INTERNAL MEMORANDUM

SUBJECT: P/25/0306 | Discharge of conditions 3 (Site investigation - land stability), 4 (signed statement), 9 (Land contamination), 13 Biodiversity enhancements), 14 Reptile Mitigation Strategy), 16 (Landscaping) and 18 (Material finishes) of planning permission P/22/0018 | Land Off Winchfawr Road (to The North Of Perthddu) Heolgerrig Merthyr Tydfil CF48 1RD

APPENDIX C – PHASE 1 MAP

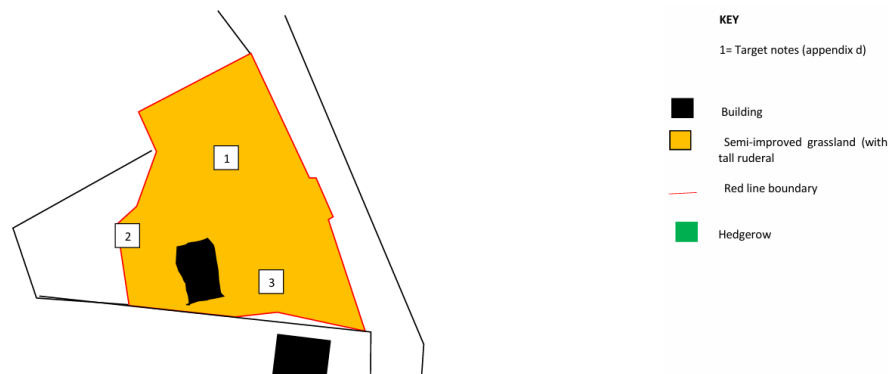
- Condition 16, specifies that the scheme must clearly identify areas of habitat on site that will be removed and those that will be retained and set out measures for their protection throughout the course of development.

As information regarding retained habitat has not been provided, it is assumed that no areas of habitat will be retained.

The onsite habitat pre-development was identified as semi-natural grassland.

- There needs to be more in the way of compensation for the grassland habitat to be lost. Suggestion – use of grasscrete to replace the permeable block paving, sown with the following seed mix - <https://wildseed.co.uk/product/mixtures/complete-mixtures/special-habitat-mixtures/flowering-lawn-mixture/> (or equivalent).
- The bird box build in model is a sparrow terrace. This should be shown in landscape – to avoid it being integrated into the wall the wrong way around.
- The bat box must be a build-in model, integrated into the house – please amend.
- There should be some separation between the two boxes – something like:
